SUBJECT: DPW PROJECT NO. 26500
Ponderosa Supervisory Area Office Upgrade/Expansion
Idaho Department of Lands (IDL)
3130 State HWY 3
Deary, Idaho 83823

Addendum No. 1

QUESTIONS AND ANSWERS

TITLE: ISD-WD1P-4-1023-65-CS-SFD
CONTROL SCHEMATIC

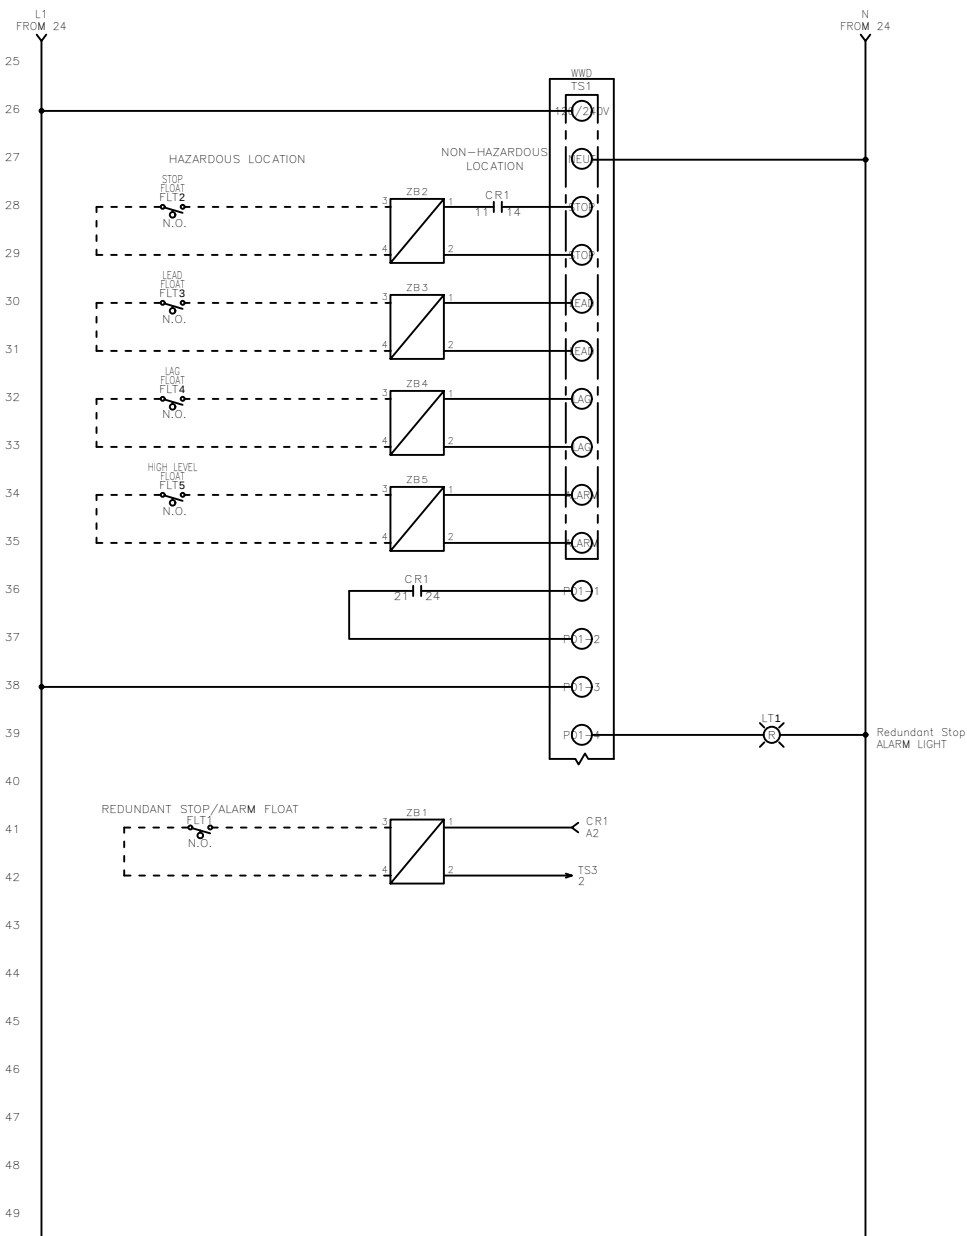
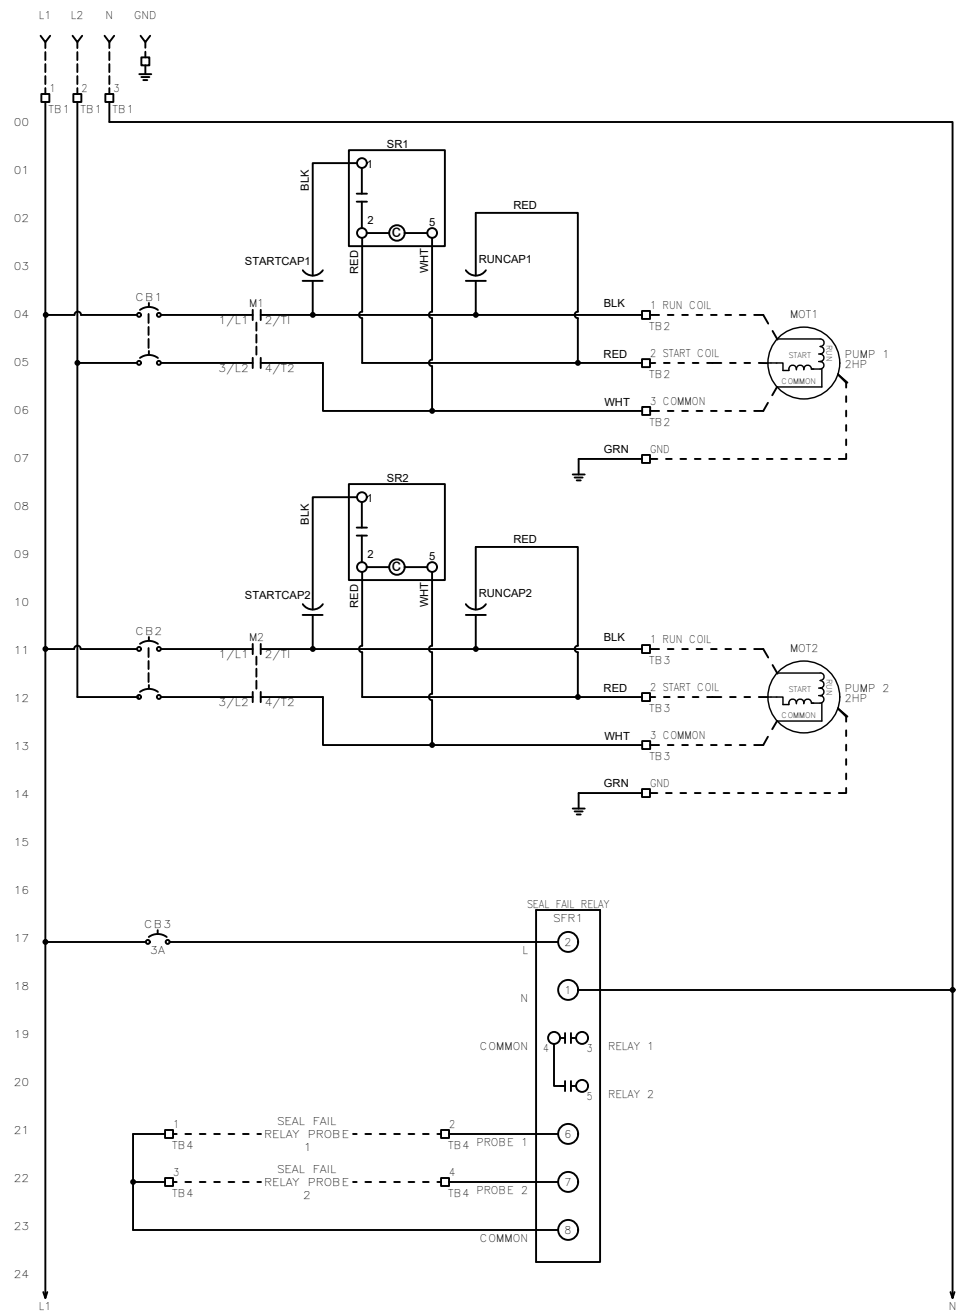
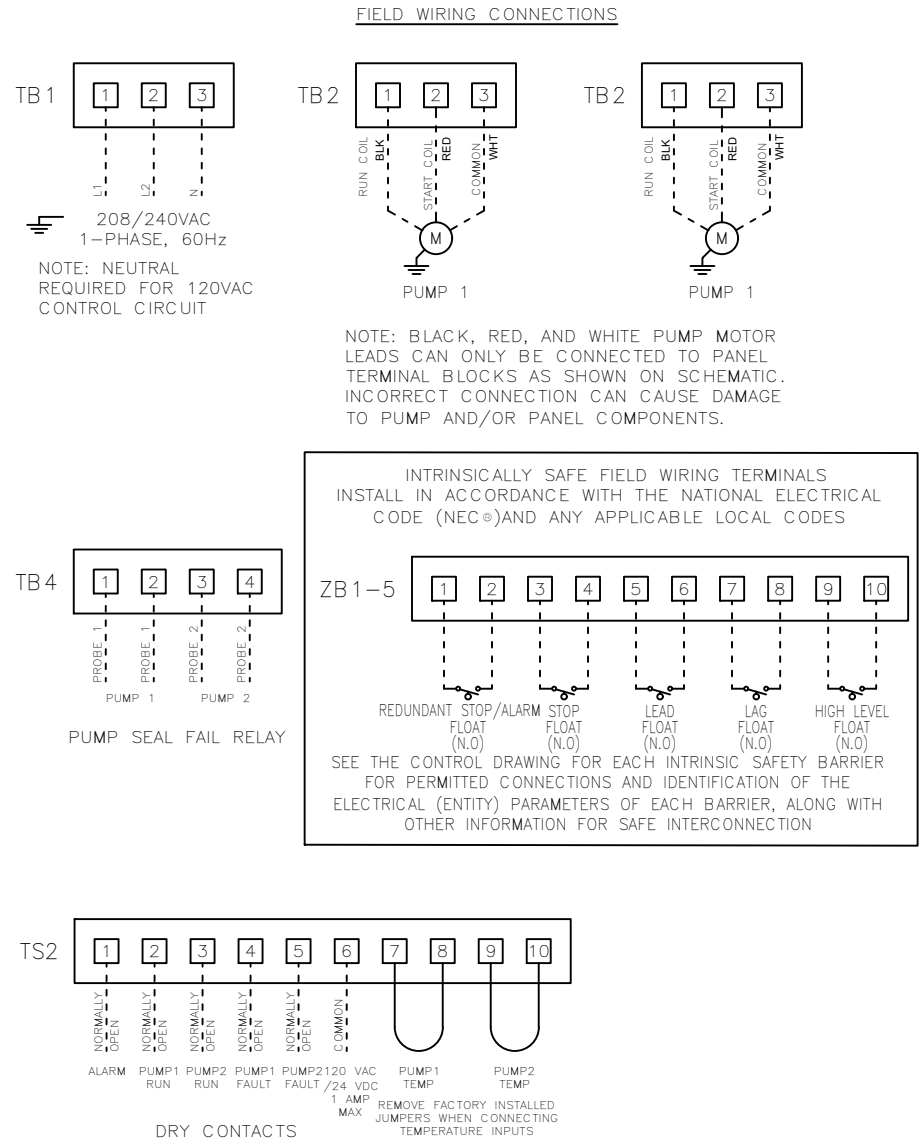
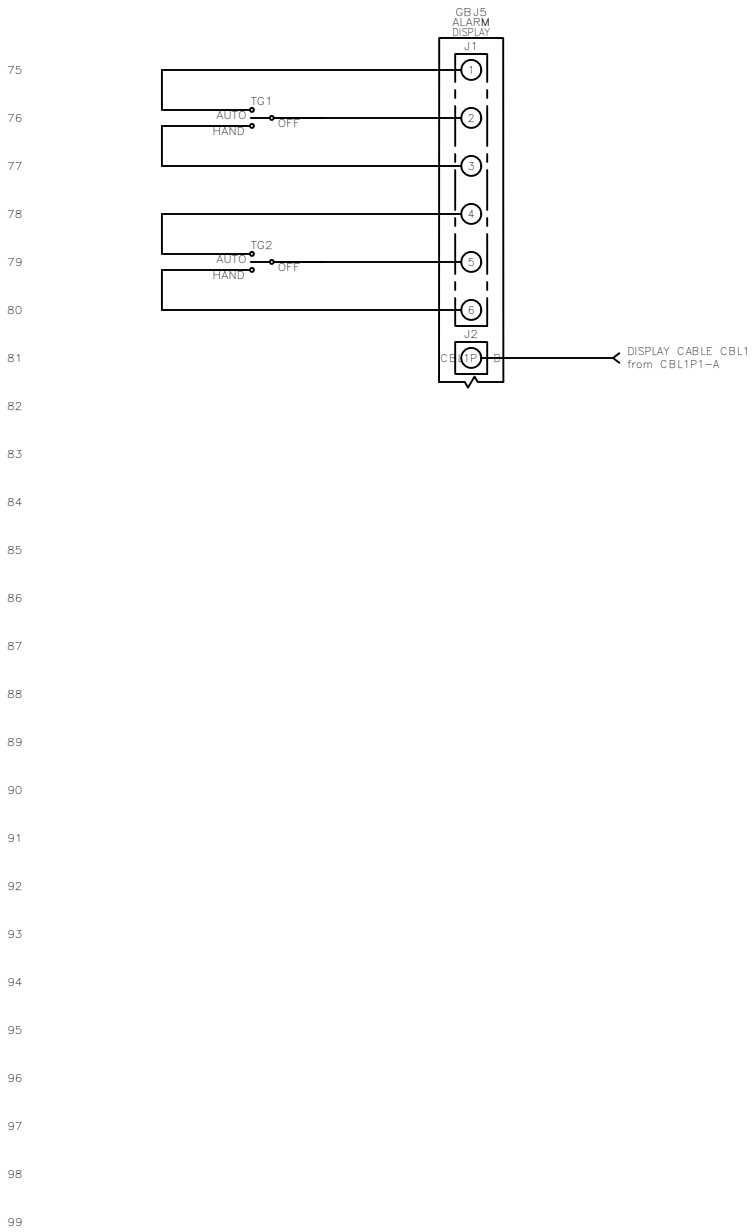
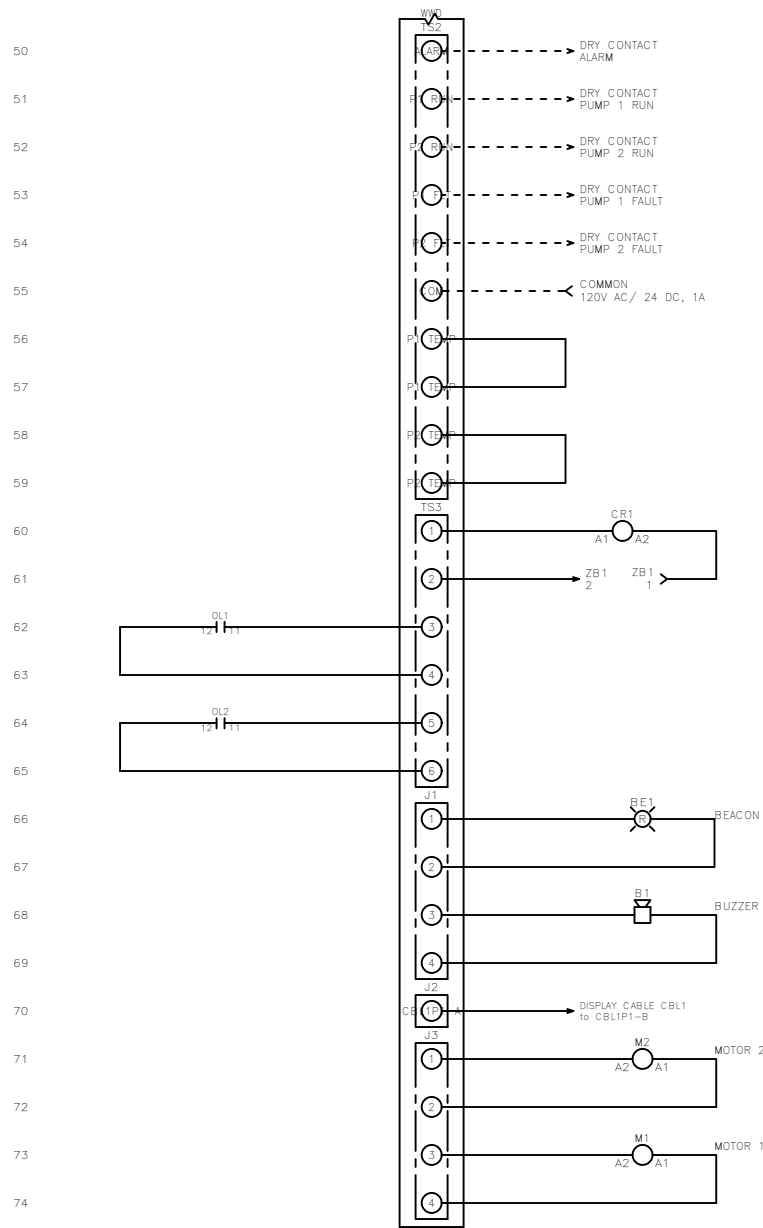
1. **QUESTION:** Can you provide the specifications for the recently installed wastewater lift station?
ANSWER: Yes, see in attachments.
